MEMORANDUM

To: Design Review Board
From: Angela Ruggeri, Senior Planner
Date: May 19, 2016
File No.: DRV16-01038
Subject: 434 Kirkland Way Mixed Use
CONCEPTUAL DESIGN CONFERENCE

CONCEPTUAL DESIGN CONFERENCE

434 KIRKLAND WAY

PROPOSED PROMENADE SECTION TYP. 2

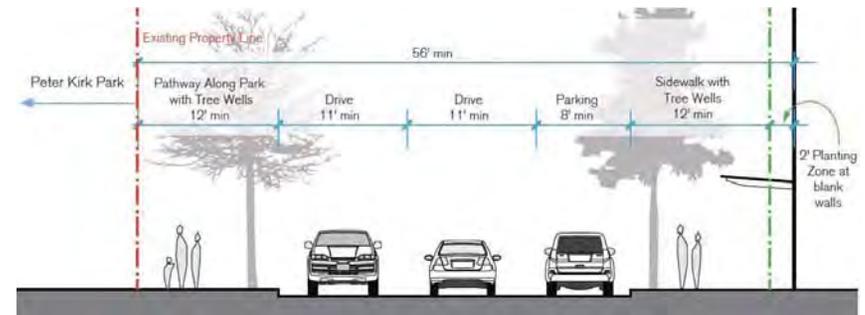
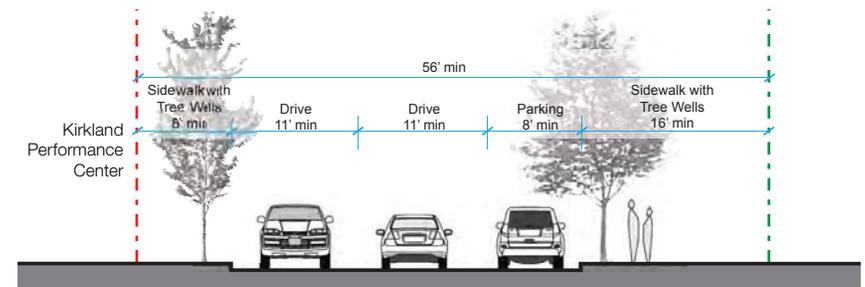
***Staff Comment:** The applicant will be requesting staff approval of a modification to the easement requirements. The proposed sidewalk reduction would still **maintain an 8' sidewalk on the west side of the easement however.** DRB input is desired before staff renders a decision.*
